**Re: EEA #15879, Tennessee Gas Pipeline 261 Upgrade Projects, Agawam, MA**

The Pipe Line Awareness Network for the Northeast, Inc. (“PLAN”) submits the following comments in response to the Expanded Environmental Notification Form (“EENF”) submitted by Tennessee Gas Pipeline Company L.L.C. (“TGP” or the “Company”) for its proposed 261 Upgrade Projects (the “Projects”).

**Greater Springfield Service Territory Infrastructure**

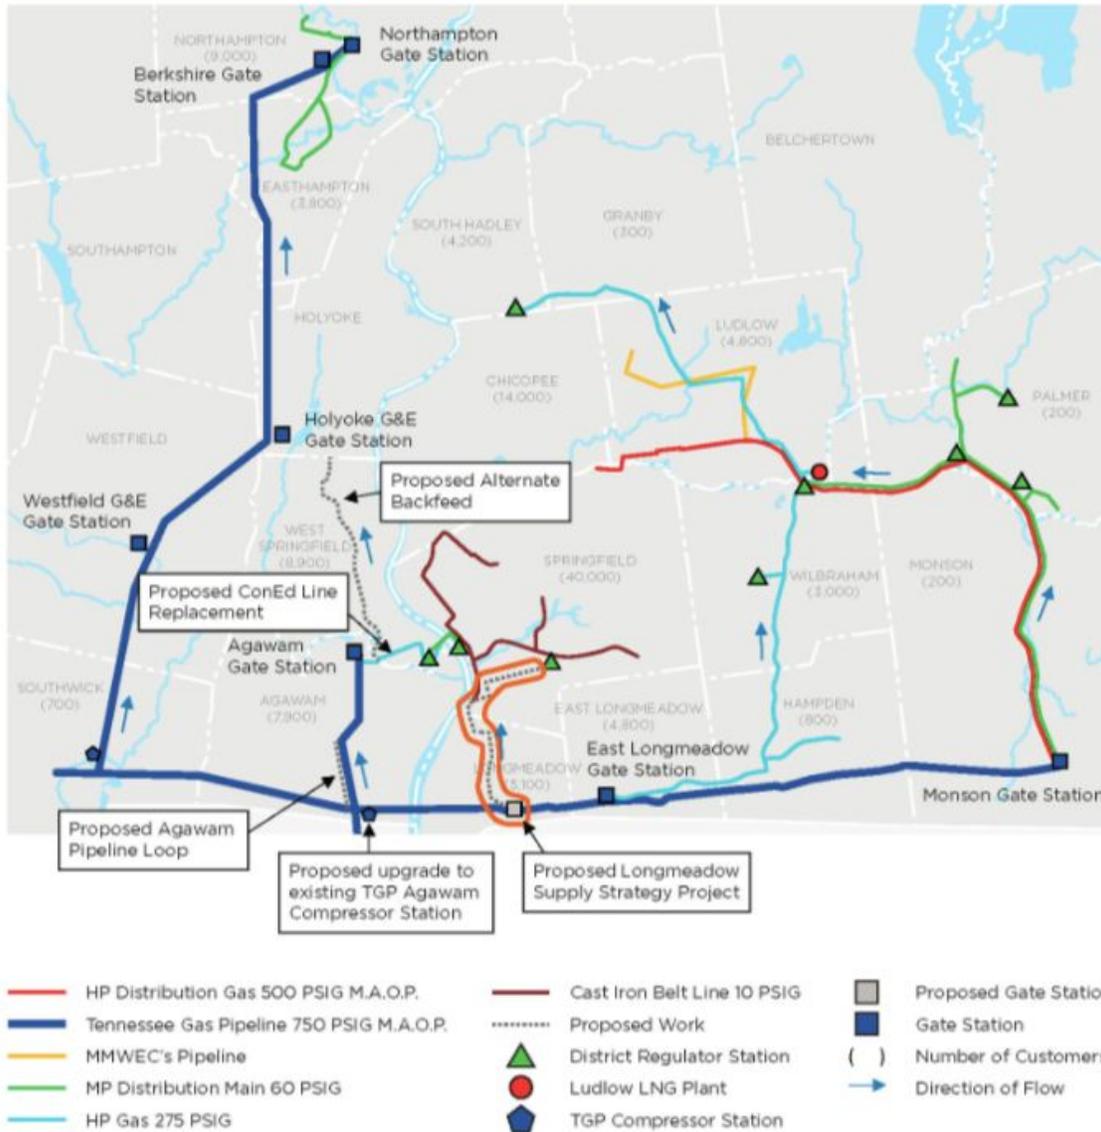
TGP refers in its EENF to a meter station that it intends to construct in June of 2019 in Longmeadow, along the Company's existing 200 Line.<sup>7</sup> The purpose of the proposed Longmeadow Meter Station is to provide Columbia Gas a point of delivery ("POD") on the east side of the Connecticut River. TGP asserts that its proposed Longmeadow Meter Station is "separate and distinct" from the instant Projects. However, the proposed new Longmeadow POD is part of what Columbia Gas calls the "Longmeadow Supply Strategy Project,"<sup>8</sup> one of the "five integrated supporting infrastructure projects" that constitute the Springfield Area Reliability Plan. **If completed, the Longmeadow Supply Strategy Project will reroute a significant amount of the current demand away from the Agawam Lateral and could eliminate any need for the Looping Project.**

A driving force behind the Springfield Area Reliability Plan is the perceived need to relieve capacity constraints on the Northampton Lateral and provide more capacity to Columbia’s Northampton/Easthampton territory by constructed new a pipeline (the proposed “Alternate Backfeed” on Columbia’s map) across West Springfield to supply HG&E, so that HG&E’s capacity on the Northampton Lateral can be made available to Columbia under a long-term capacity exchange agreement.<sup>11</sup> Columbia and HG&E have a *temporary* capacity exchange arrangement in place, whereunder Columbia provides HG&E 2,400 Dth/d of gas capacity at the Holyoke/Chicopee border, and HG&E makes that amount of capacity available to Columbia on the TGP Northampton Lateral.<sup>12</sup>

In the comprehensive alternative analysis of the Springfield Area Reliability Plan, please require analysis of system changes that would be necessary to increase capacity that Columbia could provide to HG&E at the Holyoke/Chicopee border site, rather than building a new high pressure pipeline through the entire length of West Springfield. This alternative could take advantage of LNG liquefaction and storage capacity already existing in Ludlow.
